Access Compliance Report

Public Rights-of-Way

Intersection ID: 6044	Main Street: GRENELEFE_VILLAGE_RD	Cross Street: HOSTA_DR	Location:	N
ADA ID: CFC78AD5ECA0	Ramp Type: Perp	Initial Pass/Fail: Fail	Overall Compliance: No	Severity Score: 26.25
Codes/Mitigation Info/Possible Solution		Field Measurements/Component Compliance

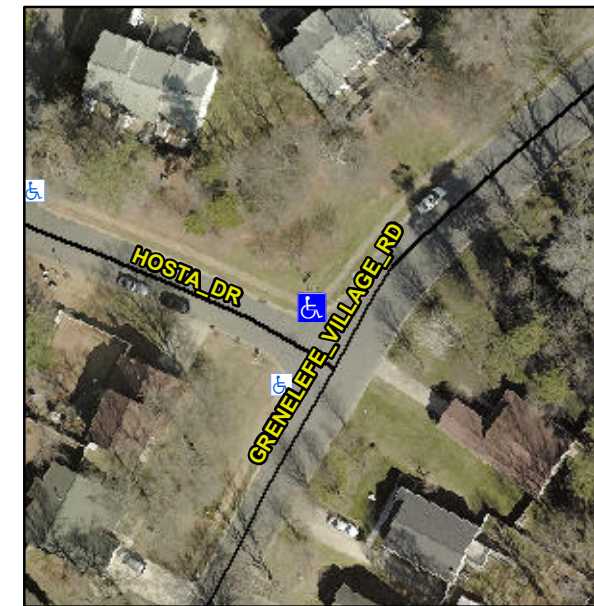
Not Found, R304.2.2, R304.5.3

Compliance	Description	Data	Compliance	Description	Data
N/A	Ramp Length (in)	47.0	No	Ramp Slope (%)	12.5
Yes	Ramp Width (in)	58.0	No	Ramp XSlope (%)	3.8
N/A	Flare Type LT	N/A	N/A	Flare Type RT	N/A
N/A	Flare Slope LT (%)	N/A	N/A	Flare Slope RT (%)	N/A
N/A	Flare Traversable LT?	N/A	N/A	Flare Traversable RT?	N/A
N/A	Landing Length (in)	N/A	N/A	DWS Provided?	N/A
N/A	Landing Width (in)	N/A	N/A	DWS Contrast?	N/A
N/A	Landing Slope (%)	N/A	N/A	DWS Length (in)	N/A
N/A	Landing X Slope (%)	N/A	N/A	DWS Full Width?	N/A
N/A	Landing Curb? (Y/N)	N/A	N/A	DWS Offset (in)	N/A
N/A	Shared Landing?	N/A			
N/A	Gutter Ponding?	N/A	N/A	Gutter Slope (%)	N/A
N/A	Gutter Lip Ht (in)	N/A	N/A	Gutter X Slope (%)	N/A
N/A	Painted X Walk1?	No	N/A	Painted X Walk2?	N/A
	X Walk 1 Direction	To SW		X Walk 2 Direction	N/A
N/A	X Walk 1 Width (in)	N/A	N/A	X Walk 2 Width (in)	N/A
	X Walk 1 Slope (%)	5.8		X Walk 2 Slope (%)	N/A
	X Walk 1 X Slope (%)	1.2		X Walk 2 X Slope (%)	N/A

Remove & Replace Entire Ramp.
